**GULF STATES UTILITIES COMPANY**

River Bend Station - Unit 1  
Docket No. 50-458

Enclosed is Gulf States Utilities Company's (GSU) response to the Safety Evaluation Report (SER) Confirmatory Item #16 (Section 6.2.3) regarding secondary containment pressure following a loss-of-coolant accident (LOCA). The analysis includes revised time delays for diesel start and fan speed-up. Although the time to reach the building design pressure increased, the dose analysis remains within the limits of 10CFR100.

FIGURE 6.2-61a

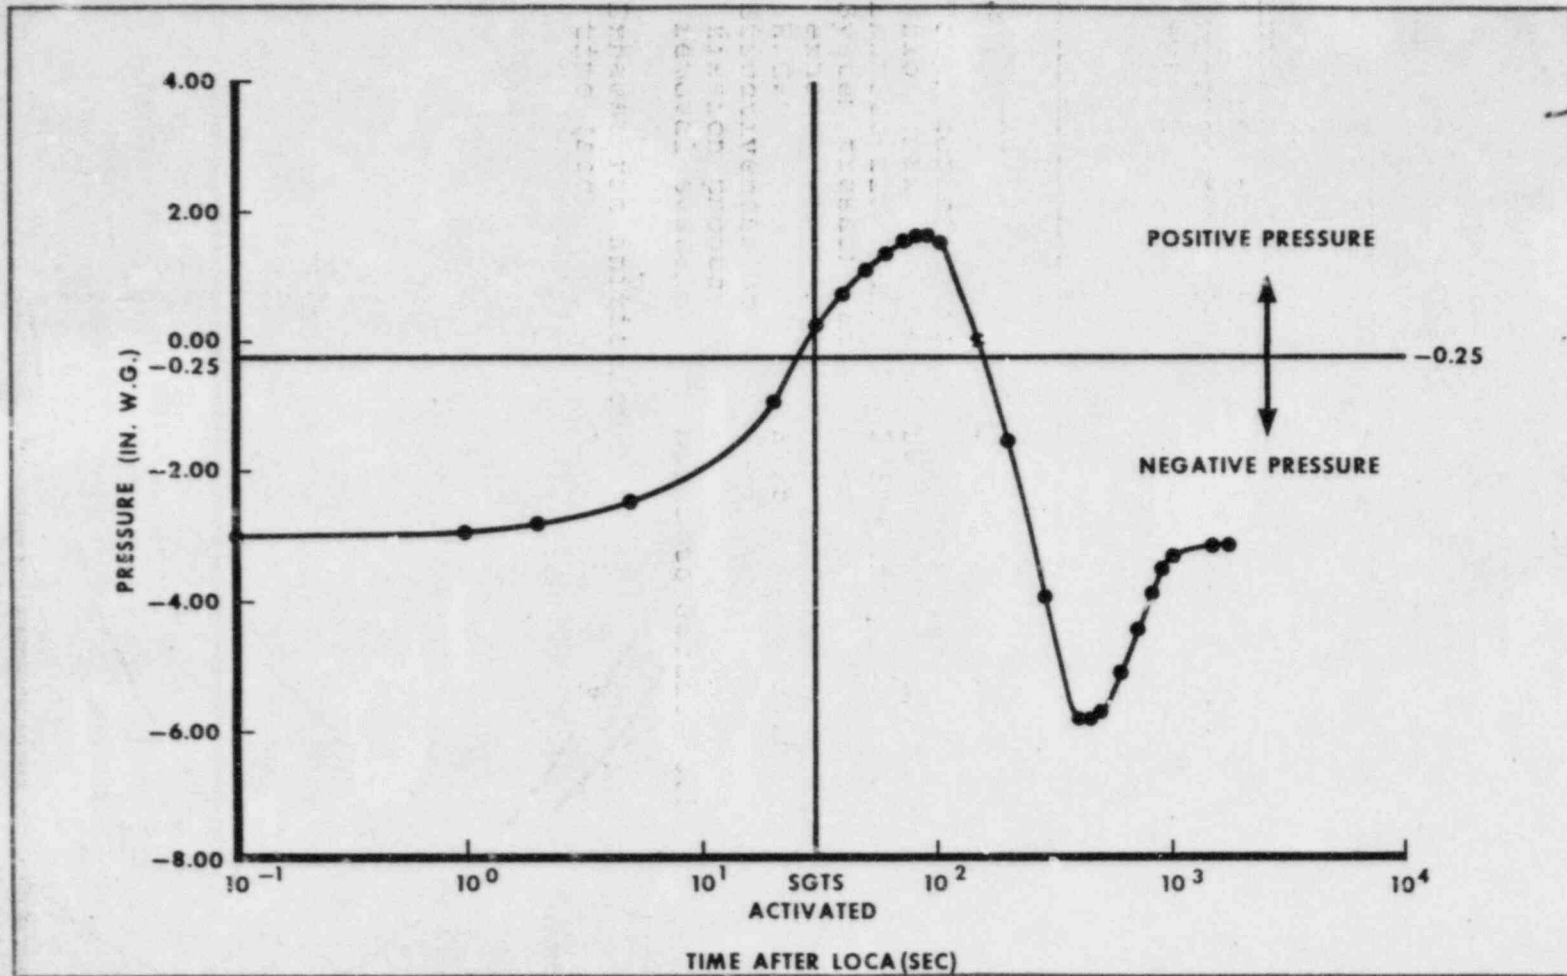
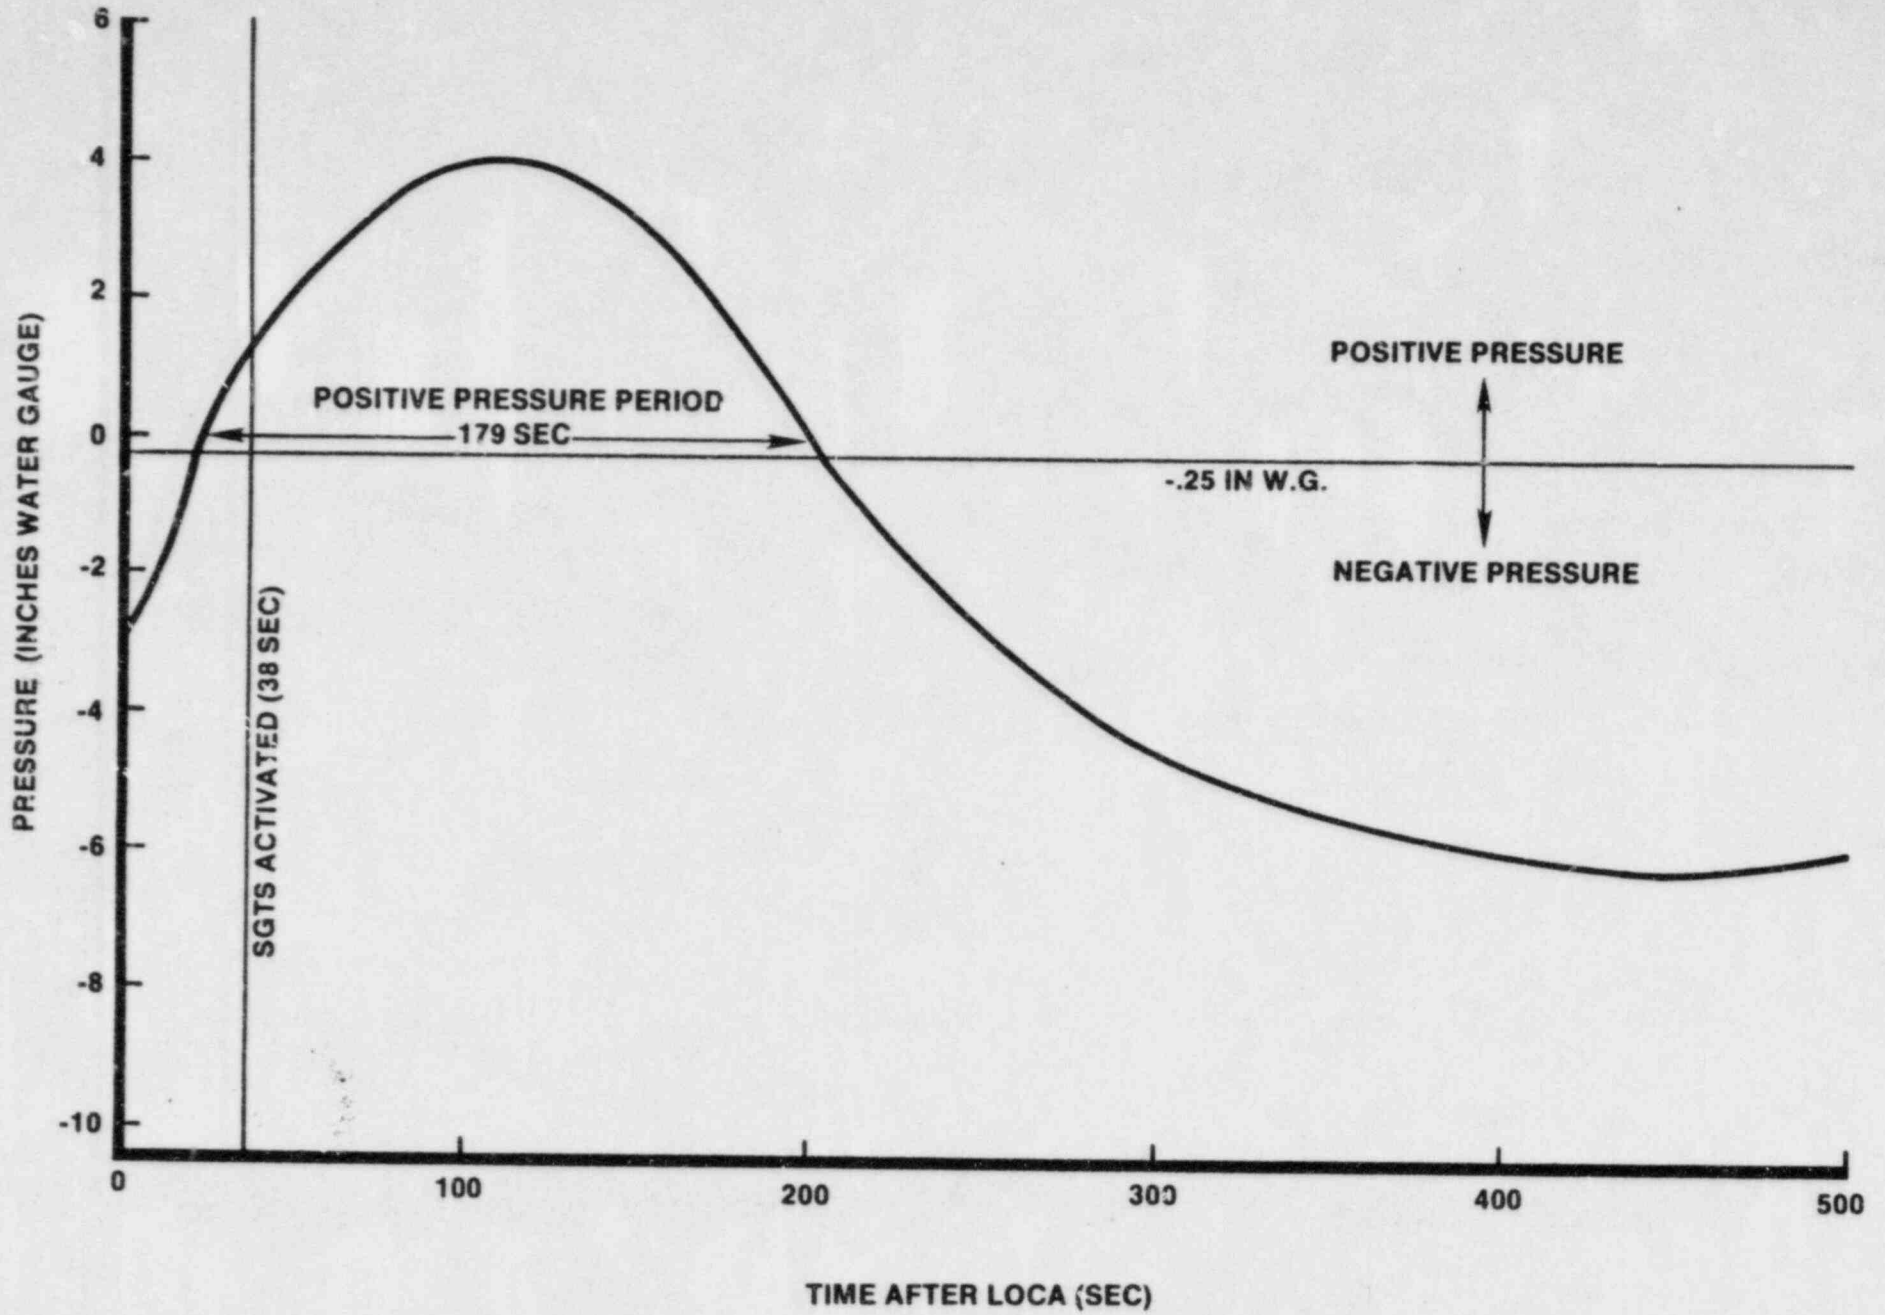
DELETE AND  
REPLACE  
WITH  
INSERT

Fig. 6.2-61a indicates that there is a period following a LCCA during which a gauge pressure greater than -0.25 in

24 W.G. exists in the annulus. This period begins  
 approximately 25 sec after the LOCA and lasts for  
 179 approximately 135 sec. The dose rate analysis during this  
 period indicates that release of contaminated air from the  
 secondary containment is within the limits of 10CFR100.

INSERT for Figure 6.2-61a

FIGURE 6.2-61b

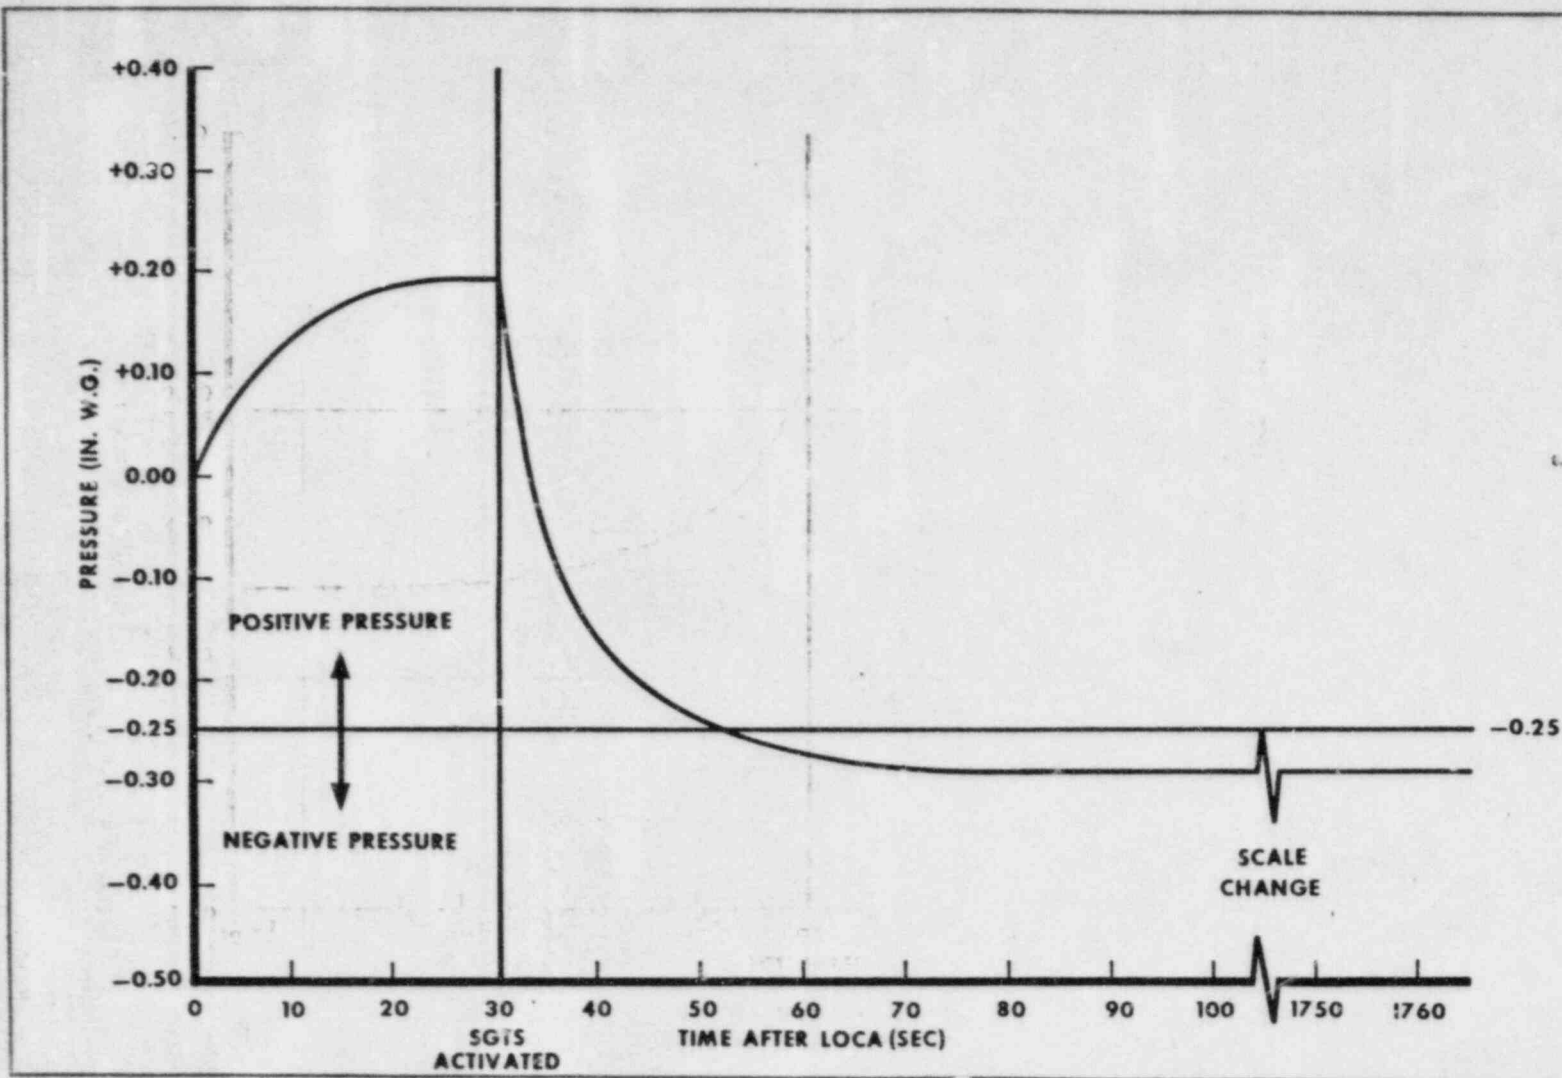
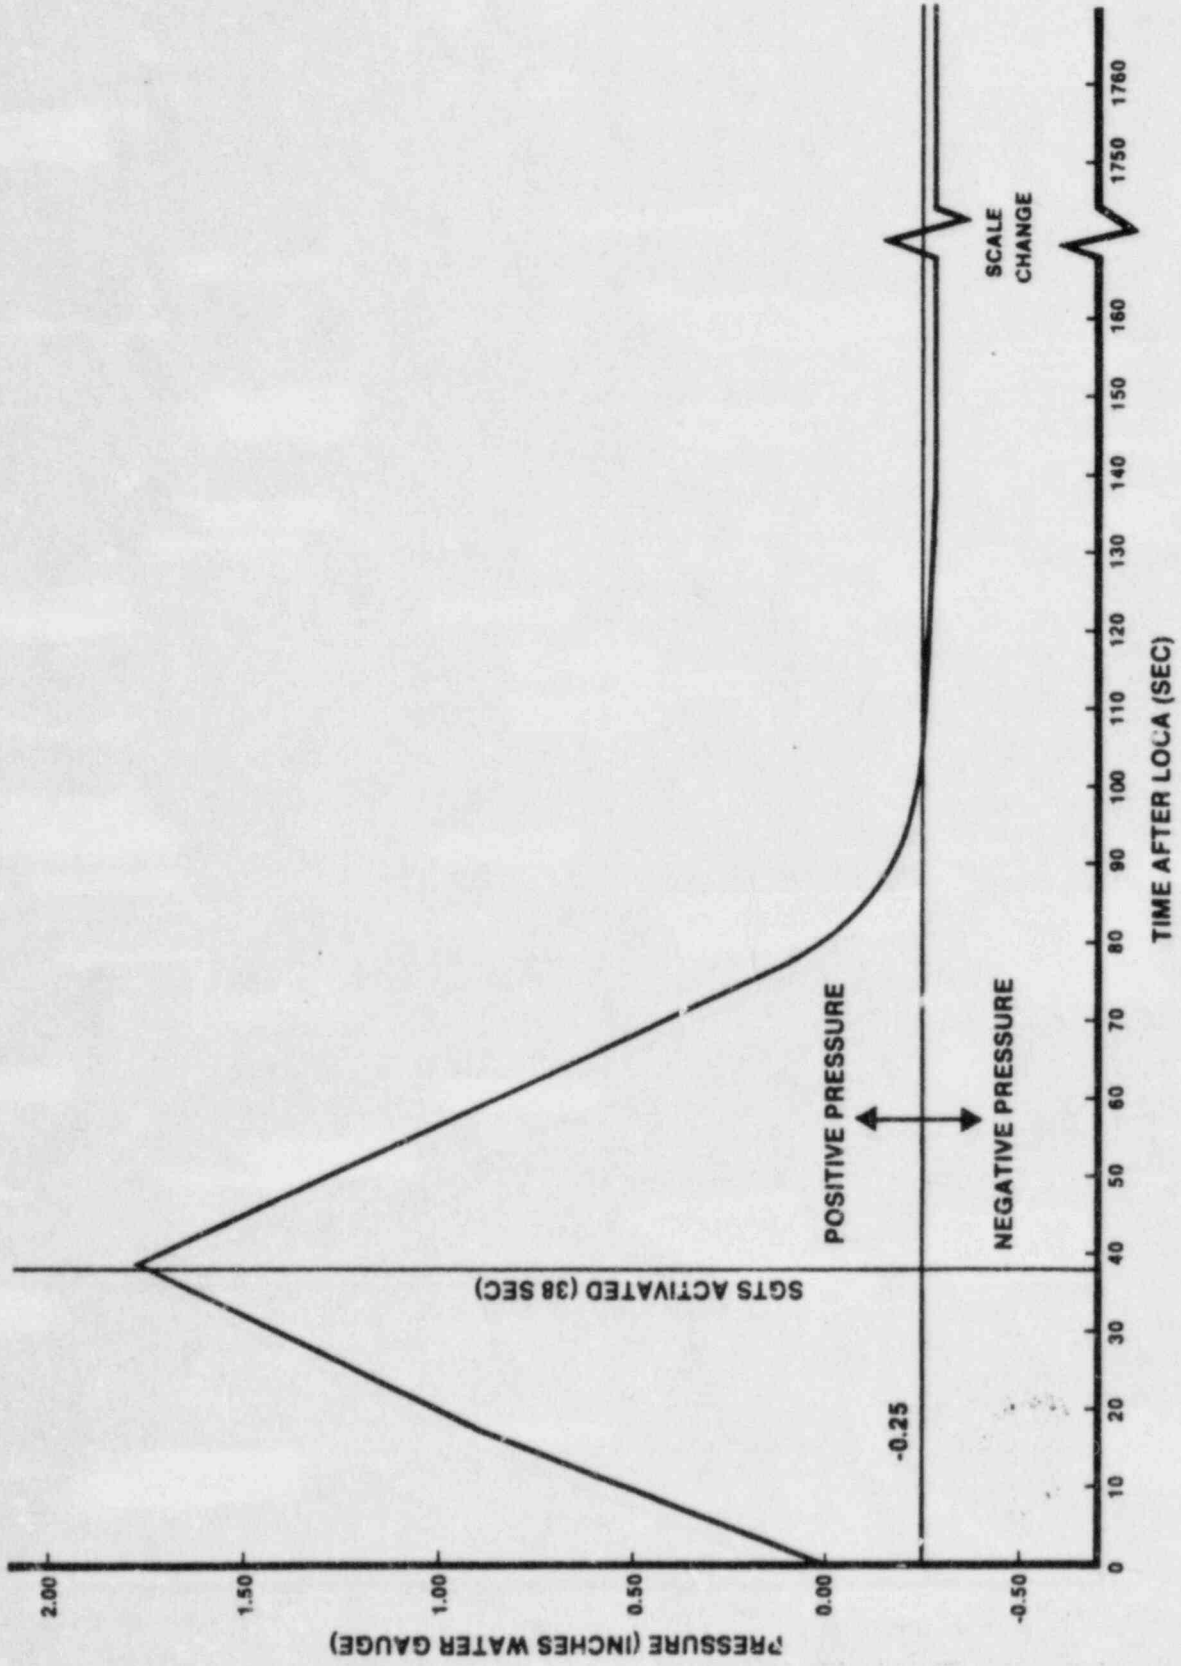
DELETE AND  
REPLACE  
WITH  
INSERT

Results of the analysis of the annulus and the auxiliary building indicate that a pressure of -0.25 in W.G. is attained in 164 and 54 sec, respectively.

INSERT for Figure 6.2-61b

FIGURE 6.2-62

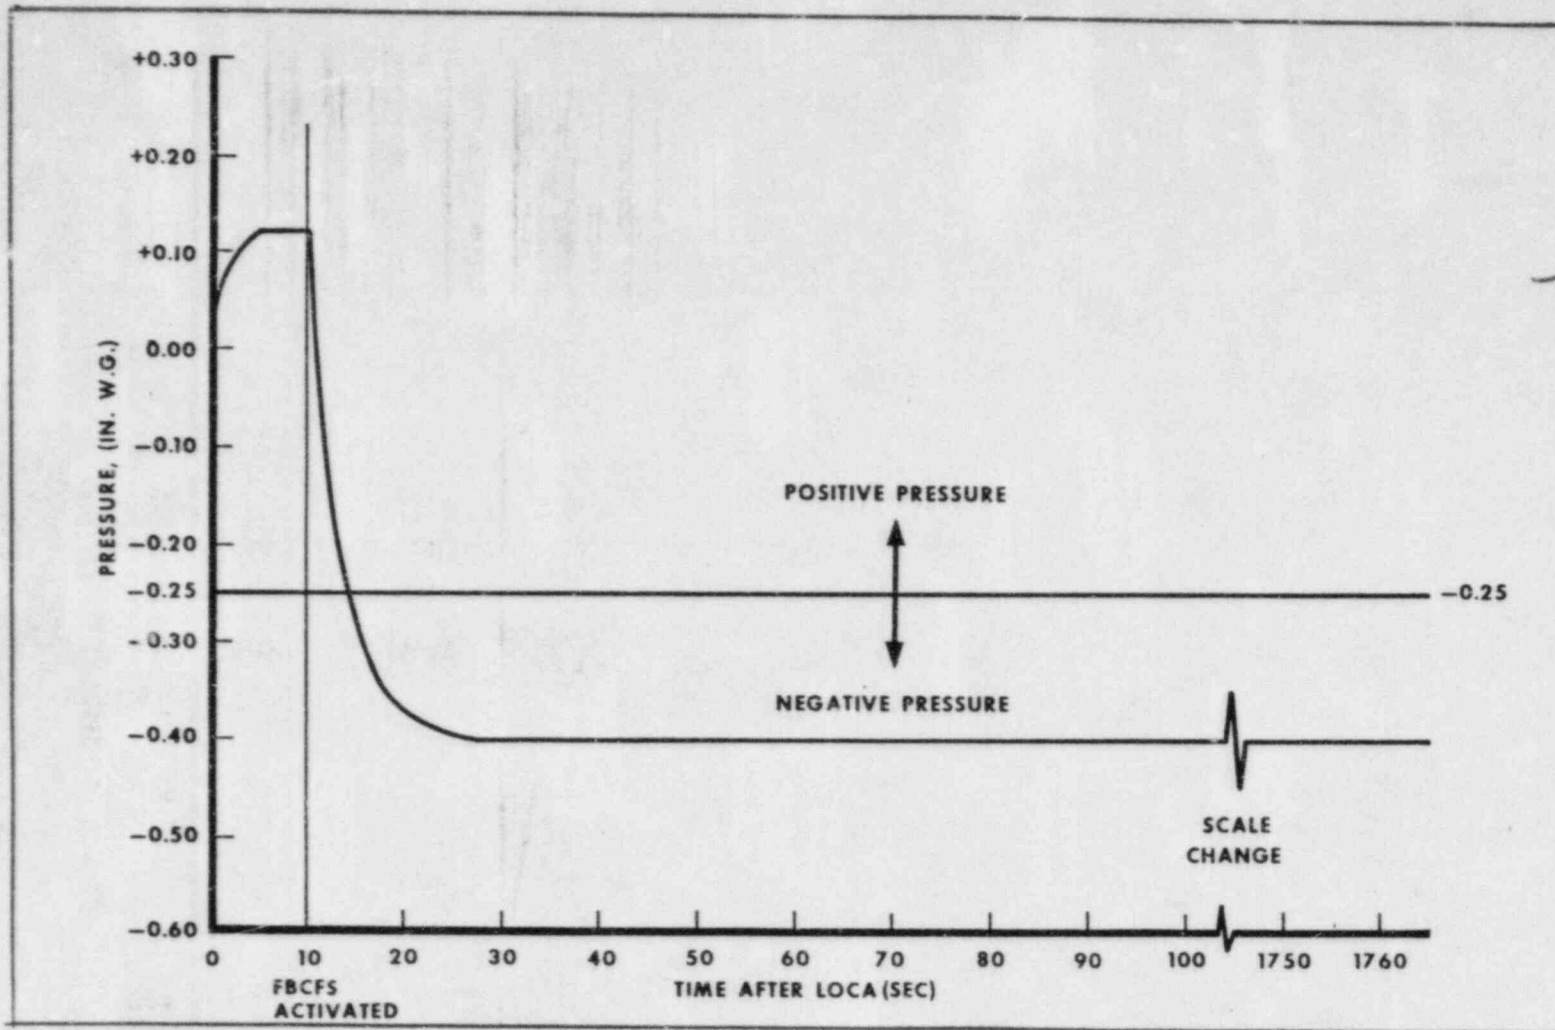
DELETE AND  
REPLACE  
WITH  
INSERT

Results of the fuel building analysis indicate that a pressure of -0.25 in W.G. will be attained in 14.5 sec.

INSERT for Figure 6.2-62
